MIL "ON" DTC P050B00 - Cold Start Ignition Timing Performance

Service Category Engine/Hybrid System

YEAR(S)	MODEL(S)	ADDITIONAL INFORMATION
2018	LS500

Some 2018 model year LS 500 vehicles equipped with a V35A-FTS engine may exhibit a MIL "ON" condition with Diagnostic Trouble Code (DTC) P050B00 (Cold Start Ignition Timing Performance). The Engine Control Module/ECM (SAE Term: Powertrain Control Module/PCM) logic has been modified to reduce the possibility of this condition occurring. Follow the Repair Procedure in this bulletin to address this condition.

Figure 1. Location of Authorized Modifications Label for 2018 LS 500

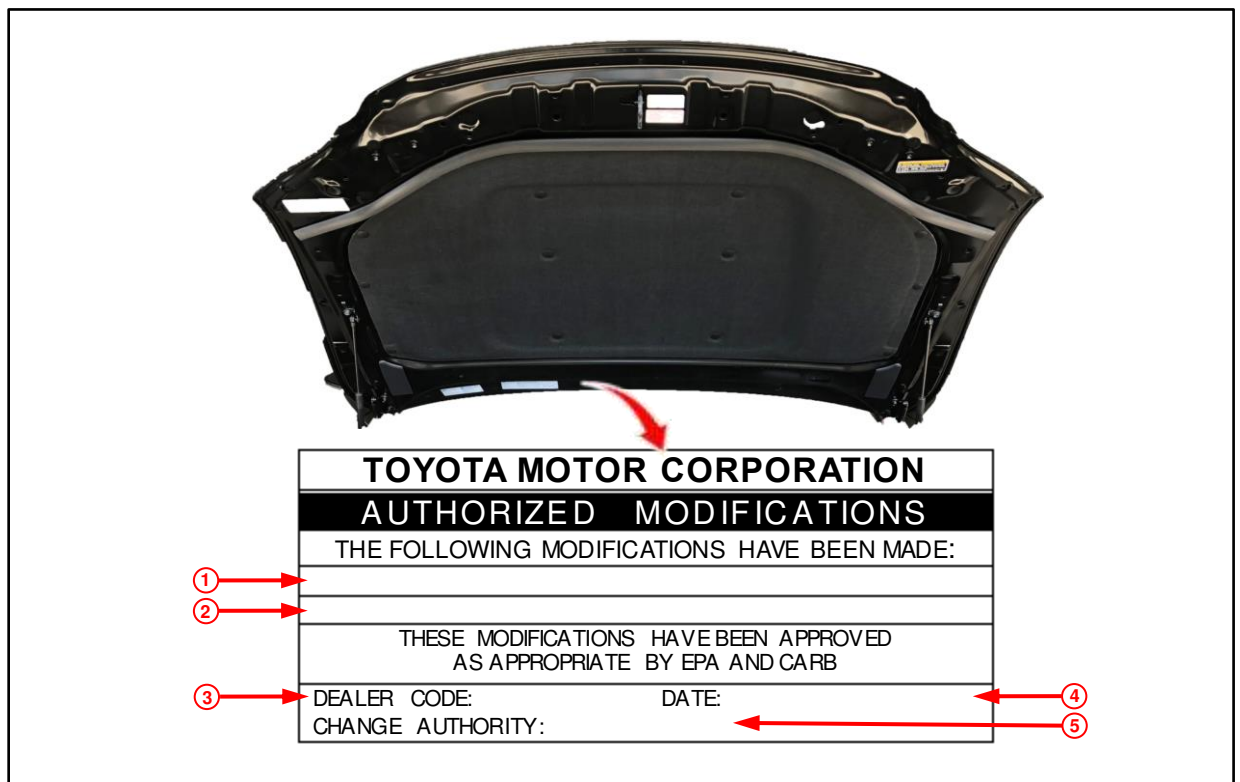
2. Check for the Authorized Modifications Label affixed to the vehicle in the location shown below. Confirm if the ECM (PCM) calibration has been updated.

4. Prepare and install the Authorized Modifications Label.
 - A. Using a permanent marker, enter the following information on the label:
 - ECM (PCM) part number [Refer to the **Parts Information** section for the **NEW PART NUMBER**]
 - Calibration ID(s) [Refer to the **Calibration Information** section for the **NEW CALIBRATION ID**]
 - Dealer Code
 - Repair Date
 - Change Authority [**This bulletin number**]
 - B. Affix the Authorized Modifications Label to the vehicle at the location shown in Figure 1. The Authorized Modifications Label is available through the MDC, P/N 00451-00001-LBL.
5. Test drive the vehicle to confirm the DTC does NOT reset.
